OLD BUISNESS: 2-12-2020 MEETING  
APPLICATION NUMBER 19-6464  
VIOLATION NUMBER 19-322  
ADDRESS: 4801 STURTEVANT  
HISTORIC DISTRICT: RUSSELL WOODS - SULLIVAN  
APPLICANT: WAYNE GROLEAU  
DATE OF APPLICATION: 9-23-2019  
DATE OF VIOLATION: 9-26-2019

### **CASE SUMMARY**

**RE: Application Number 19-6464; 4801 Sturtevant; Russell Woods-Sullivan Historic District**

4220 Sturtevant where the original stucco was sided over

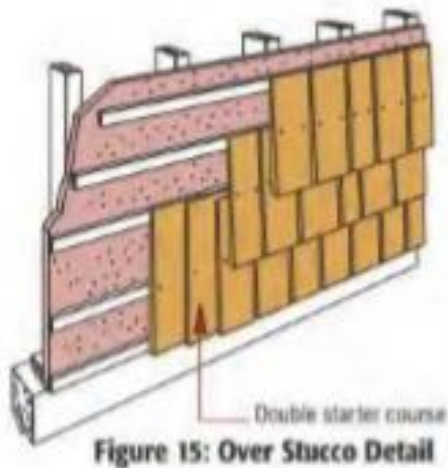
Dragomir Cosanici and Nicholas Bozon from the State Historic Preservation Office wrote a paper titled Economic Hardship, Feasibility and Related Standards in Historic Preservation Law. This report happened to talk about stucco and wood siding. “An example of the lack of feasibility would involve a house sided with a unique circa 1920s stucco, when there was no longer any company in the state doing repair work on stucco homes. In such a case, siding the home with another historically correct material, such as wood, might be considered economically and technically feasible, whereas using stucco might not be viewed as feasible.” This shows that both stucco and wood siding are historically correct solutions. We went the extra mile to do the original stucco with half timbering at a greater cost and higher level workmanship. In addition to the previous documentation showing the cottage shakes on upper rear elevation were not original, we have the following additional documentation for the stucco.

Your applicant found that wood strips were attached to the stucco to nail the shakes to. This is a practice shown below. The bottom shakes were placed directly over the lap. The second floor door was not original.

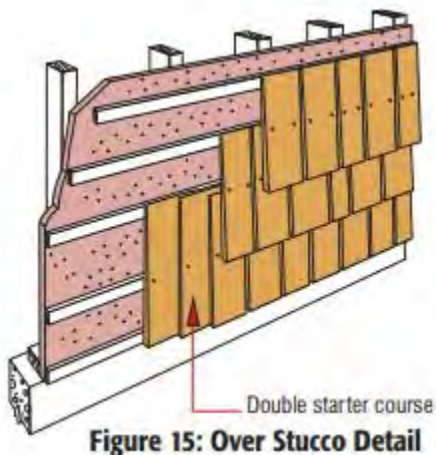
We don't agree on whether the wood shakes at rear were salvageable

Why would I spend all this money and time if I could just paint the existing shakes?
